City of Detroit  
Inter-Departmental Communication

**RE:** Petition No. 504  
Request to Outright Vacate Martin Place And the East/West private easement in  
Bound By Woodward, Alexandrine, John R., And Mack

**NOTICE OF PROPOSED CHANGE IN PROPERTY**

Petition: x504

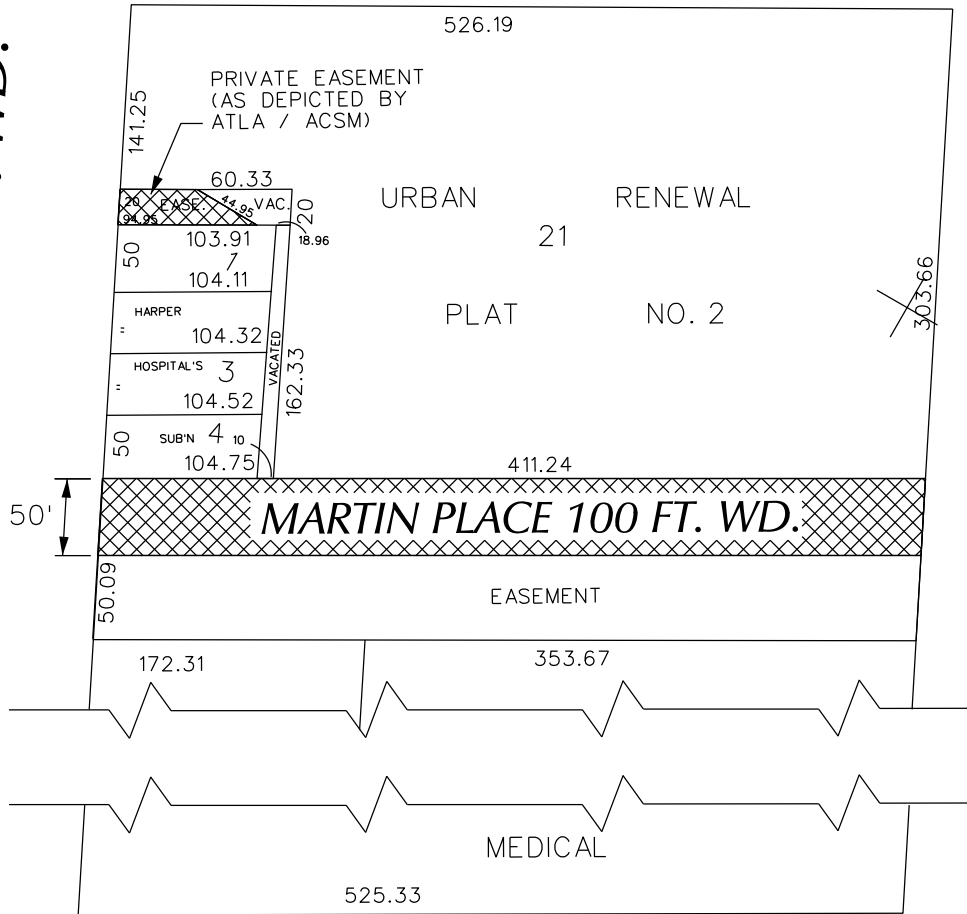
The Detroit Water and Sewerage Department (DWSD) is in receipt of the subject petition. There are a water mains and sewers located in Martin and the Easements. DWSD has no objection to the requested vacations provided that the following conditions are met:

- The water mains and sewers service no other properties and only service the properties owned by the Petitioner, if not the Petitioner must prepare a relocation plan for the water mains and sewer signed by a Registered Engineer, DWSD approves the relocation plans, and the Petitioner grants a satisfactory easement for the relocated water and sewer. The Petitioner is to bear the entire cost of the proposed relocation plans, including construction, demolition, permitting, inspection, survey, etc.
- If DWSD is to maintain ownership of the existing sewer a satisfactory easement is to be granted by the Petitioner.

The entire work is to be performed in accordance with DWSD specifications and standards, all of the fees are to be deposited with DWSD in advance, to cover the necessary costs of permits and inspection.
